TOWN OF PARADISE VALLEY

Lincoln Drive Median Improvements

December 6, 2018

KIMLEY-HORN FIELD OBSERVATIONS

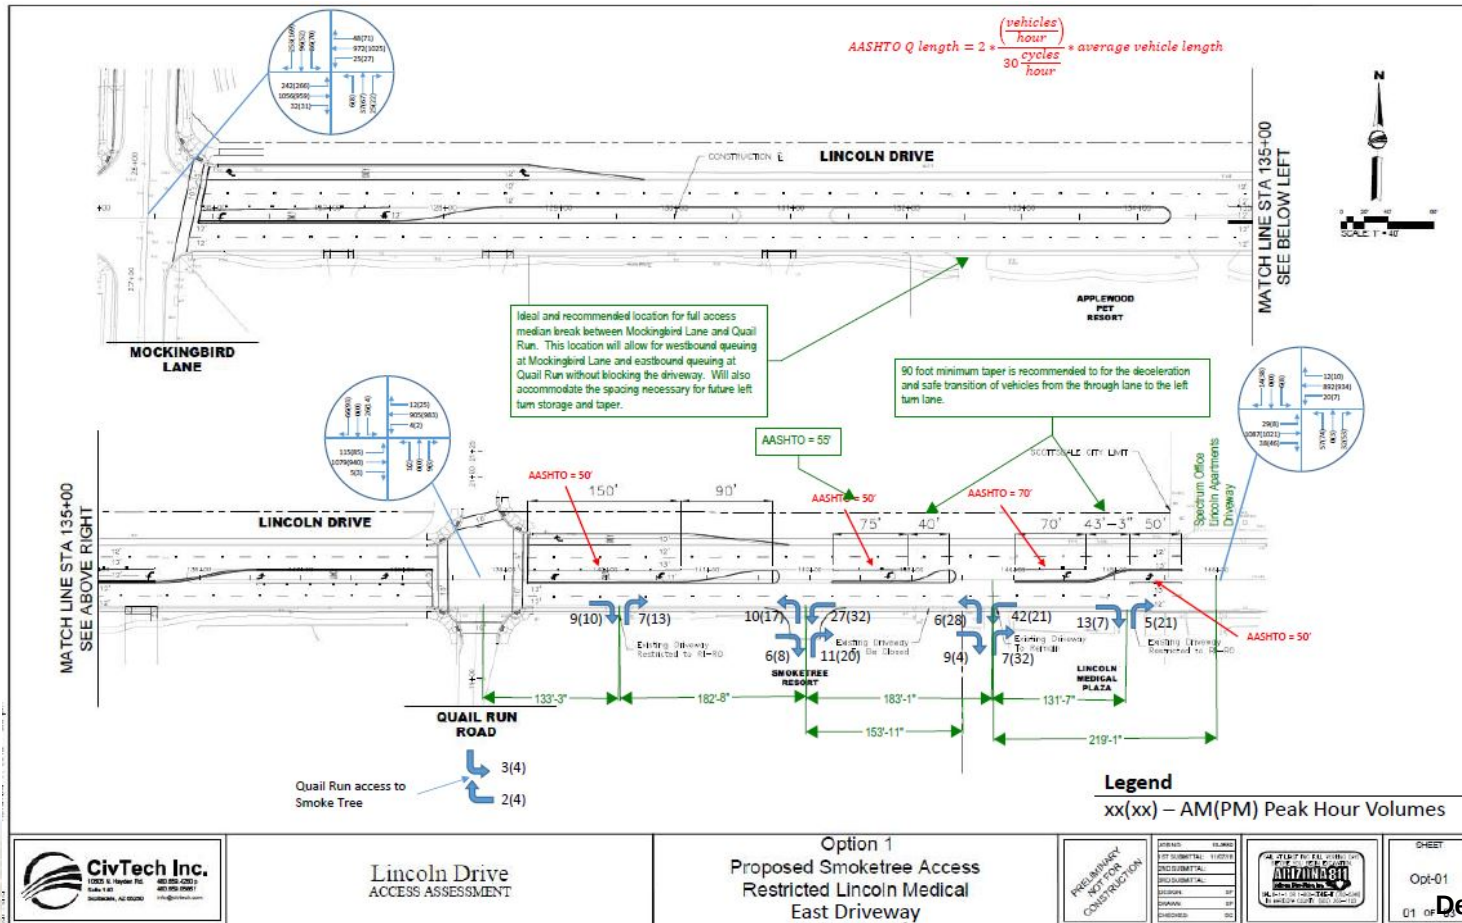
Eastbound Lincoln Drive traffic backup past Smoke Tree Resort eastern entrance.

OPTION #1 (FULL ACCESS)

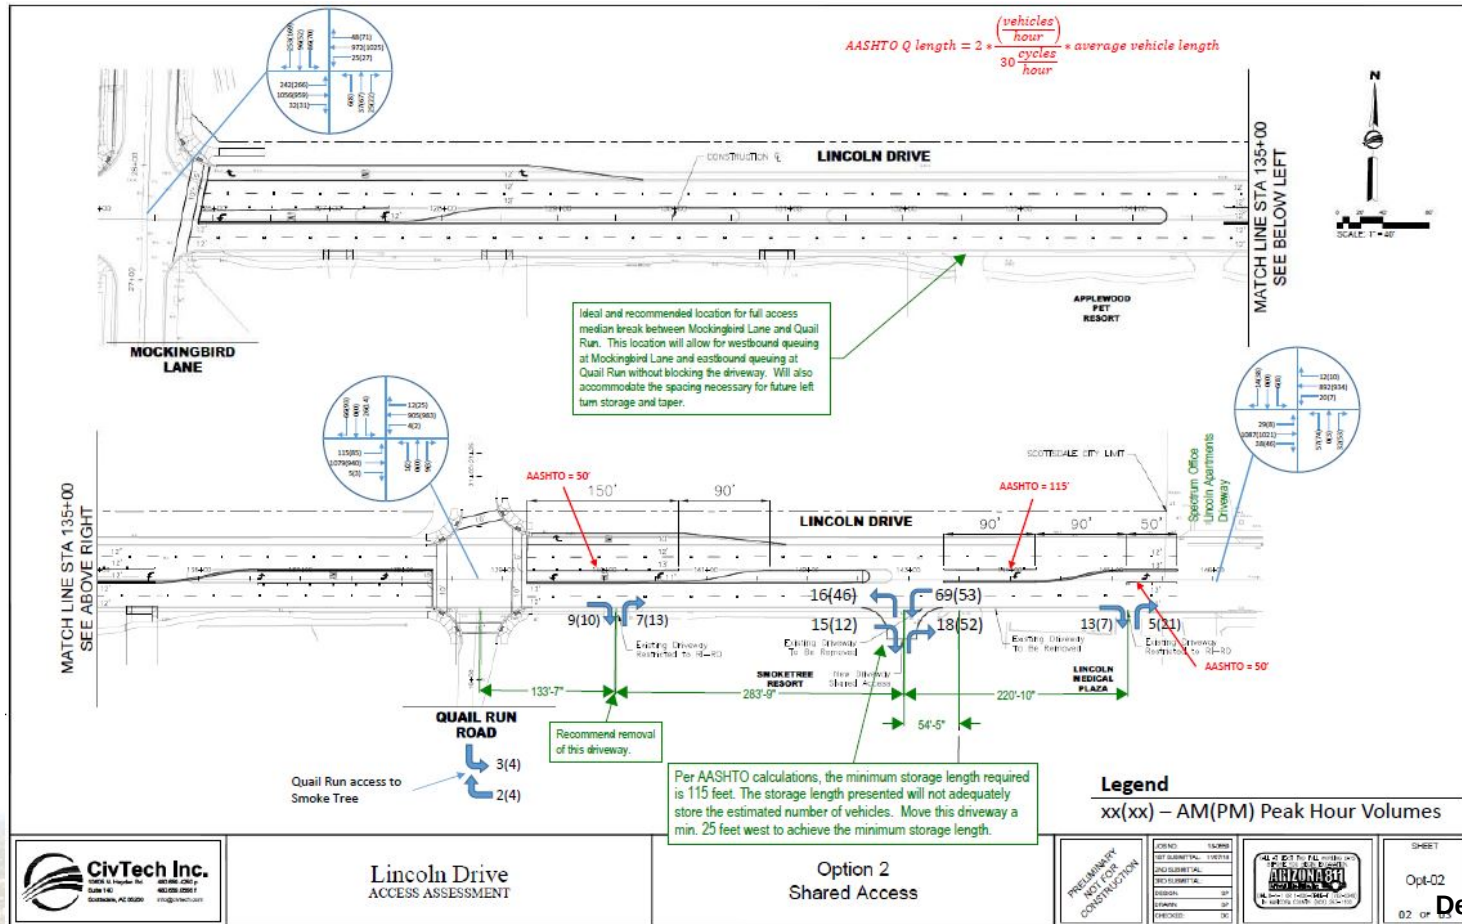
- The eastern driveway is right in/right out only and is in its current location.
- The western driveway has a median break for full access and is in its current location.
- The western driveway minimum left turn taper length is 90'. Only 43'-3" is provided.
- The western driveway minimum left turn storage requirement is 70'. A storage length of 70' is provided and is adequate.
- Driveway spacing is approximately 132' and does not meet the minimum requirement of 250'.

- The western driveway is right in/right out only and is in its current location.
- The eastern driveway has a median break for full access and is moved to a new location approximately 183' from the Lincoln Medical Plaza western driveway (approximately 154 feet from the eastern property line).
- The eastern driveway minimum left turn taper length is 90'. Only 40' is provided.
- The eastern driveway minimum left turn storage requirement is 55'. A storage length of 75' is provided and is adequate.
- The driveway spacing does not meet the minimum requirements of 250' from Quail Run Rd. or adjacent driveway.

Staff does not recommend full access for both properties as shown since driveway spacing is not met and left turn taper lengths do not meet the minimum standards necessary to safely transition vehicles from the Lincoln Drive through lane into the left turn lanes. Kimley-Horn's traffic observations also show that eastbound traffic will back up in front of the Lincoln Medical Plaza's driveways.

OPTION #2 (SHARED FULL ACCESS)

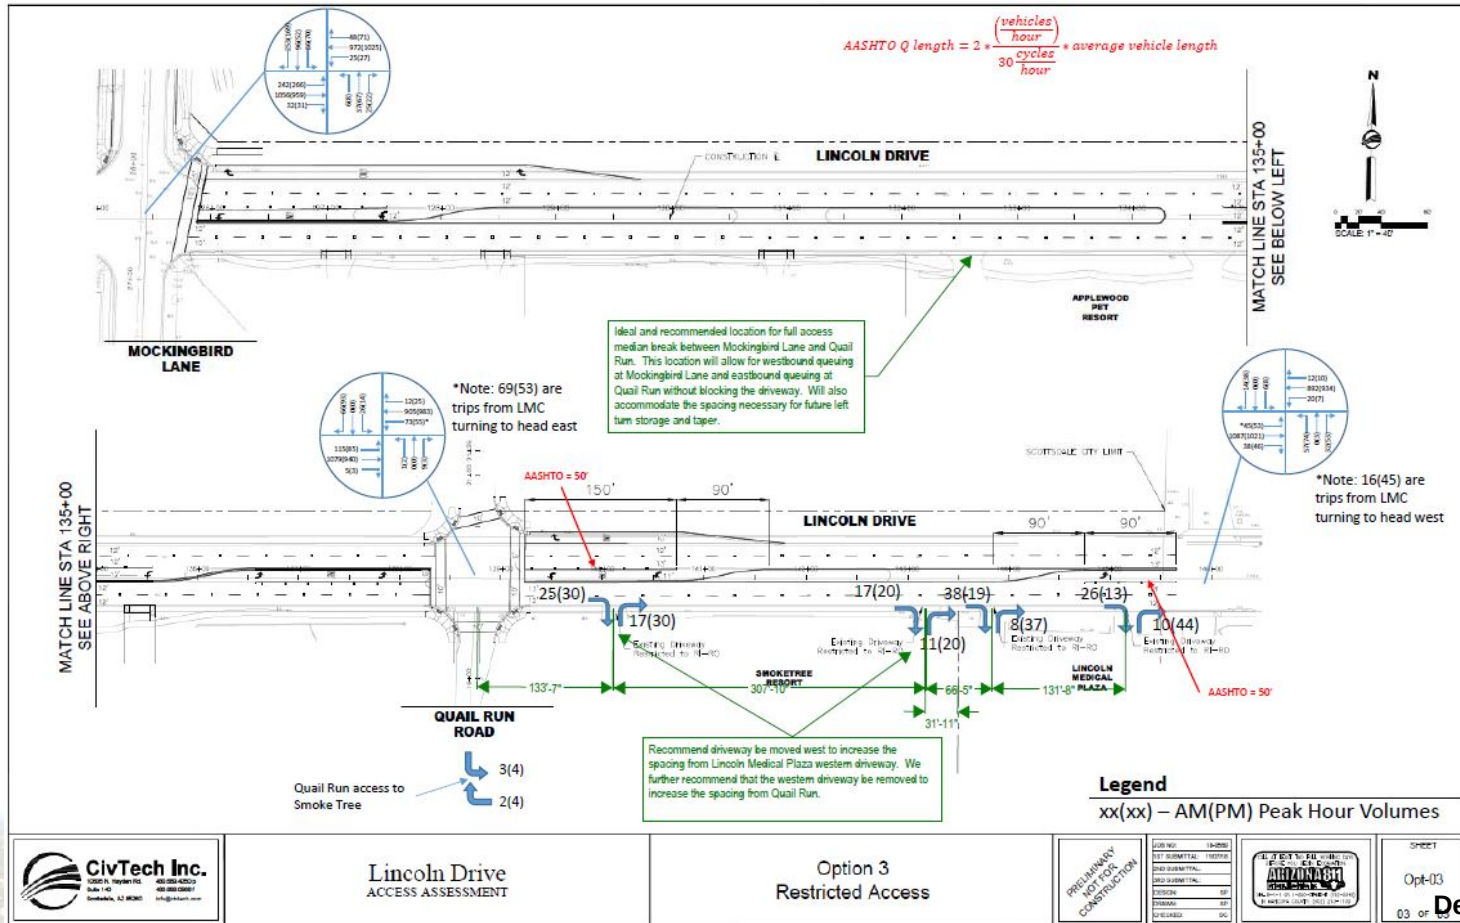
- The Lincoln Medical Plaza eastern driveway is right in/right out only and is in its current location.
- The Lincoln Medical Plaza western driveway has been removed.
- The Smoke Tree Resort western driveway is right in/right out only and is approximately 134' east of Quail Run Rd.
- The shared access driveway is shown at a location approximately 54' west of the joint property line.
- The shared access driveway minimum left turn storage length on Lincoln Drive is 115'. Only 90' is of storage is provided.
- The shared access minimum left turn taper length is 90'. A left turn taper length of 90' is shown and is adequate.

Staff recommends that that left in/left out shared access can be provided so long as the minimum left turn storage length on Lincoln Drive is extended from 90' to 115'. The Smoke Tree Resort western driveway shall be removed since it cannot meet the minimum spacing requirement of 250' from both Quail Run Rd. and the shared access driveway. A dedicated right turn deceleration lane (minimum 100' storage and 90' taper) is also recommended for the shared access driveway.

Additionally, a non-vehicular access easement (NVAE) shall be placed along the eastern and southern property lines of the Lincoln Medical Plaza parcel to prevent future access from the AJs Shopping Complex and Andaz Resort.
